Seismic Walkdown Checklist (SWC)

Project: DC Cook 2 SWEL

Location (Bldg, Elev, Room/Area): AB2, 587.00 ft, 121

Equipment ID No.: 2-QT-142-AB2

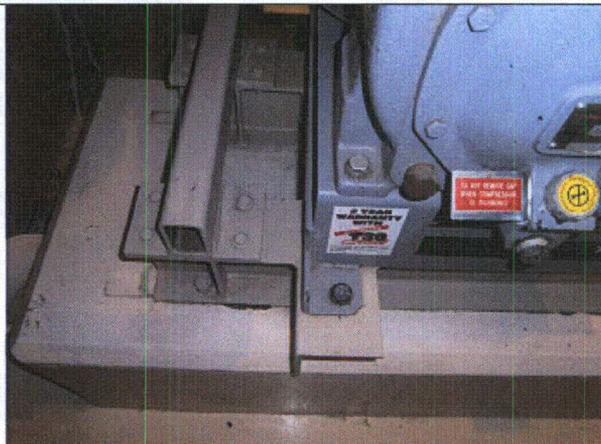
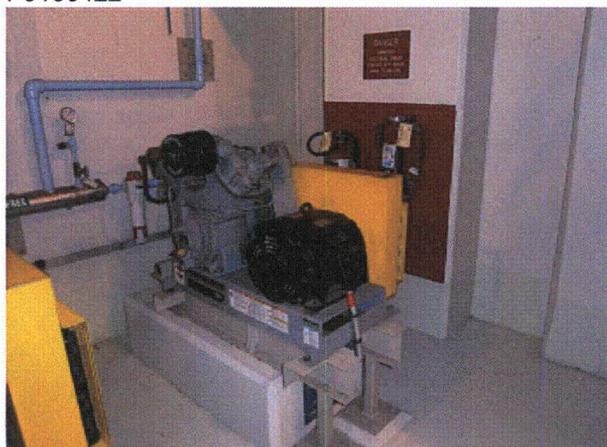
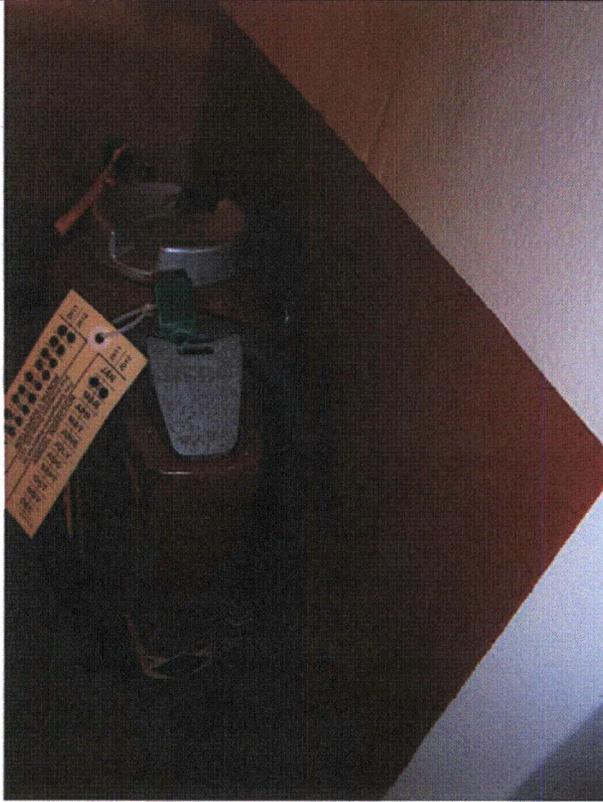
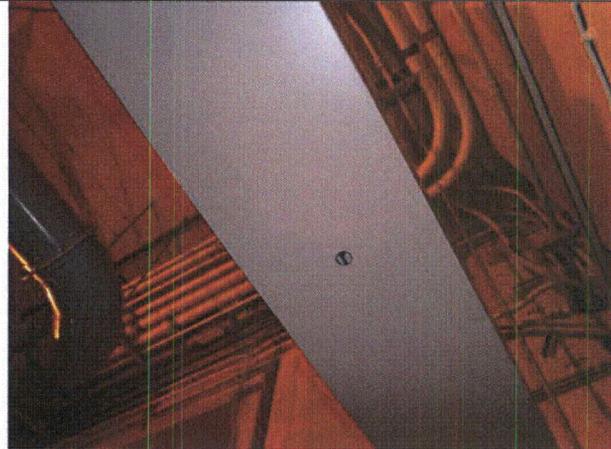
7. Are soft targets free from impact by nearby equipment or structures? No

Fire extinguishers on short hooks - AR 2012-11669 was issued.

10. Based on the above seismic interaction evaluations, is equipment free of potentially adverse seismic interaction effects? No

Equipment ID No.: 2-RPST-B

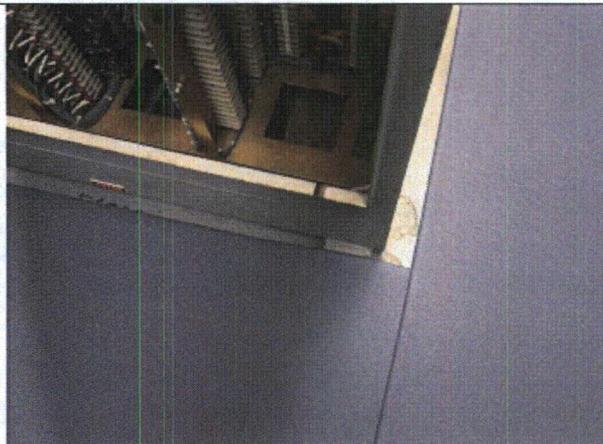
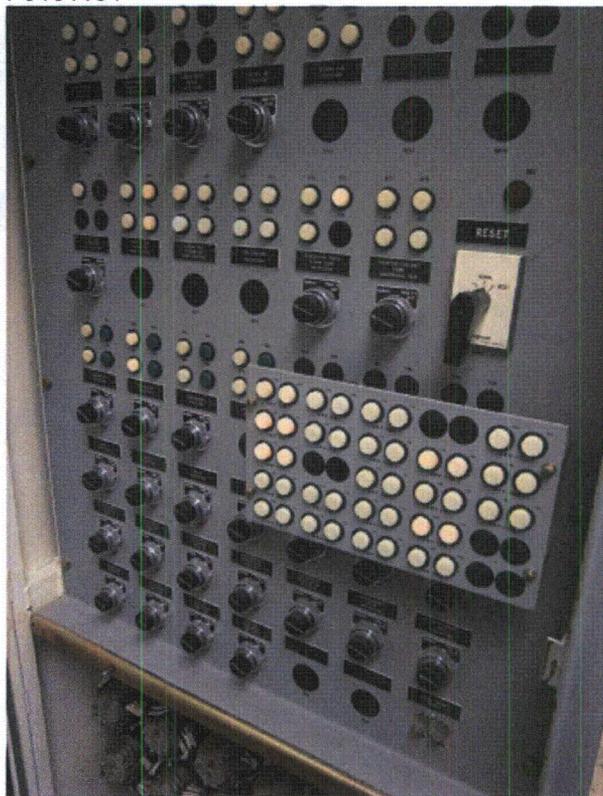
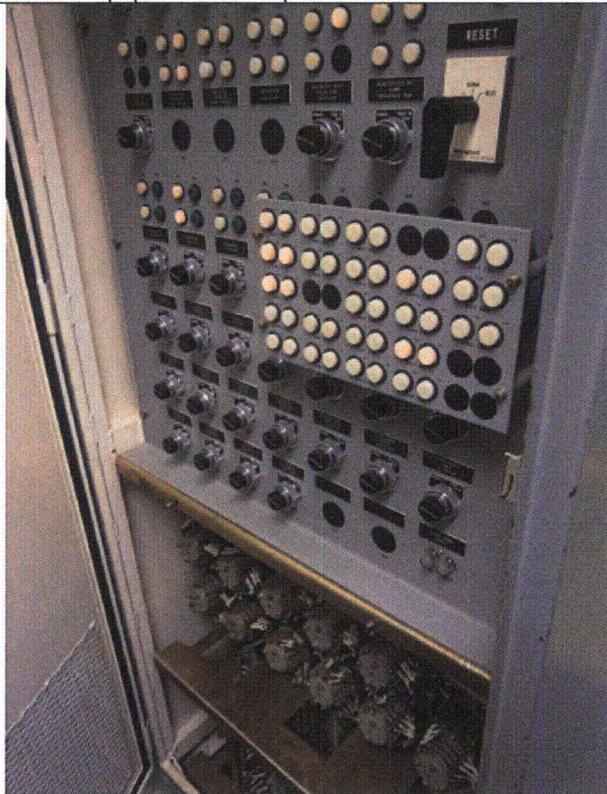
5. Is the anchorage configuration consistent with plant documentation? (Note: This question only applies if the item is one of the 50% for which an anchorage configuration verification is required.) No
SQUG documents identify 2-RPST-B but label it as 2-RPSX-B. AR 2012-12911 and AR 2012-12913 were issued to address documentation discrepancies found.

6. Based on the above anchorage evaluations, is the anchorage free of potentially adverse seismic conditions? No

Equipment ID No.: 2-RPSX-B

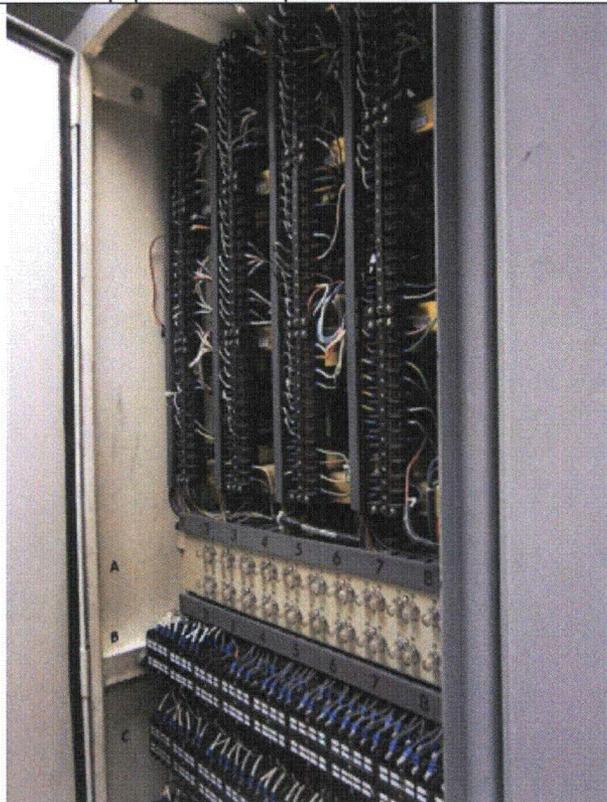
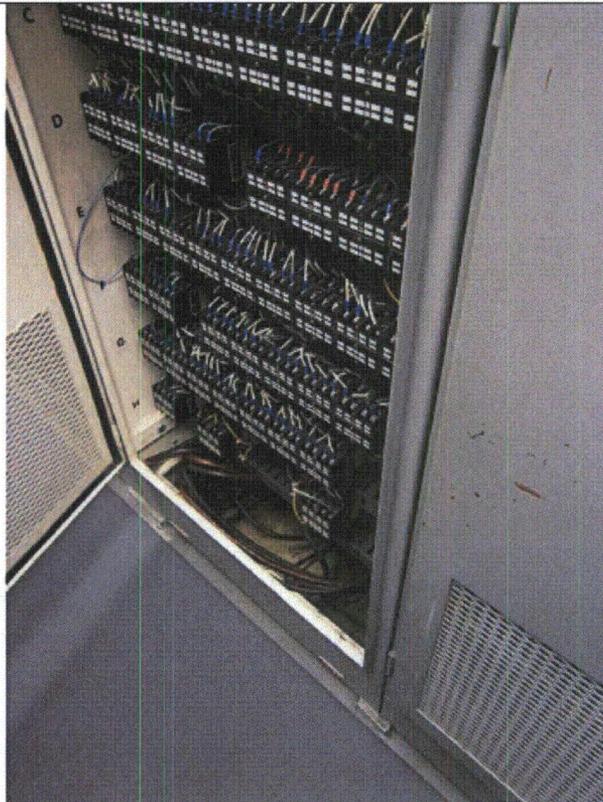
5. Is the anchorage configuration consistent with plant documentation? (Note: This question only applies if the item is one of the 50% for which an anchorage configuration verification is required.) No
Documents identify 2-RPST-B but label it as 2-RPSX-B. AR 2012-12911 and AR 2012-12913 were issued to address documentation issue.

6. Based on the above anchorage evaluations, is the anchorage free of potentially adverse seismic conditions? No
